Re: Environmental Compliance Audit – Dial-a-Dump (EC) Pty Ltd – Environment Protection Licence Number 13426

ATTACMENT A: EPA response to Genesis Pty Ltd email dated 25 March 2018

Condition E4.1 a. d. &e.

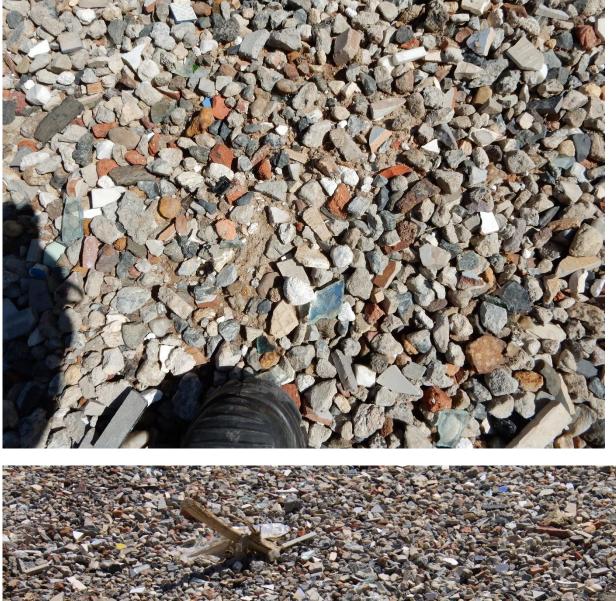
The licensee's representative was present and as stated in the draft report, measured the alternative cover material and at no time did he disagree with the auditors at that time. The attached photos clearly indicate that this material is alternative cover material consisting of crushed concrete, crushed bricks, crushed clay tiles and crushed glass.

The EPA would also like to point out that the specification for the drainage material as referenced in condition O5.23 requires that the material be a minimum of 20mm and a maximum of 40mm and must not be angular. If this was drainage material, then the licensee is in breach of the specification of the drainage material.
